Oconee Nuclear Station

Technical Discussion on Cable Testing and Proposed Modifications
December 15, 2015

Follow-up Questions

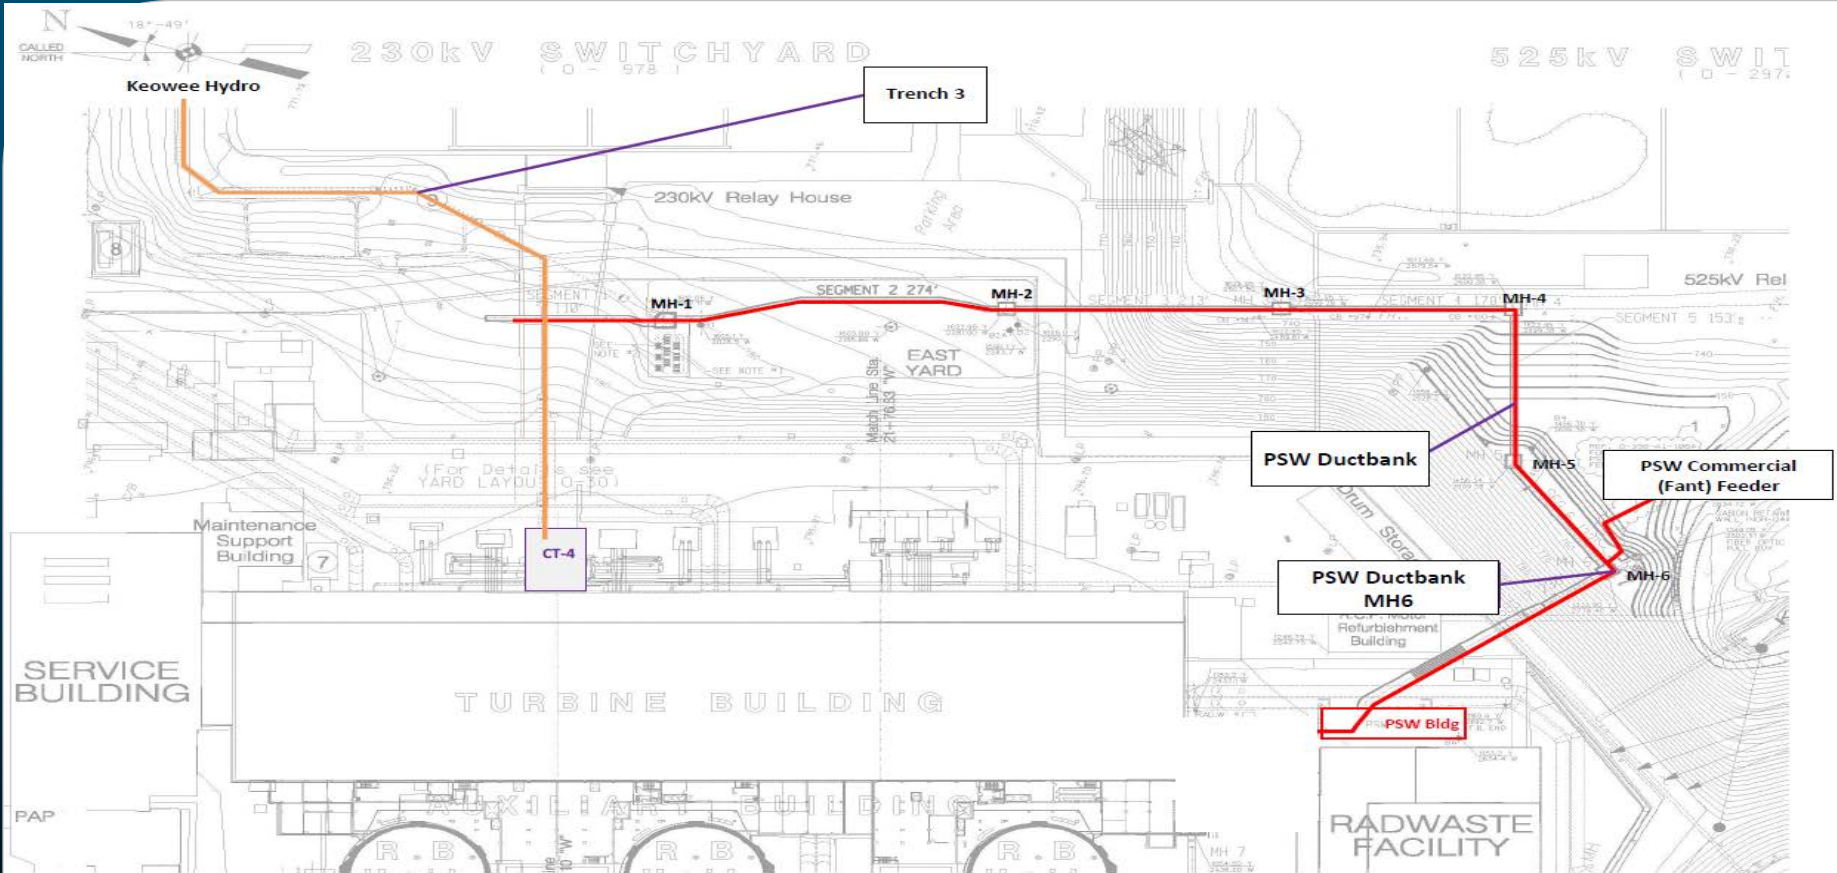
These three follow-up questions refer to Oconee feedback on the “Background” section of the NRC Questions.

1. Why was 12 gauge wire used in tests 3 & 4?
[previously covered]
2. Demonstrate why the current was not split [between the three cables]?
3. What quality standards were used to determine this?
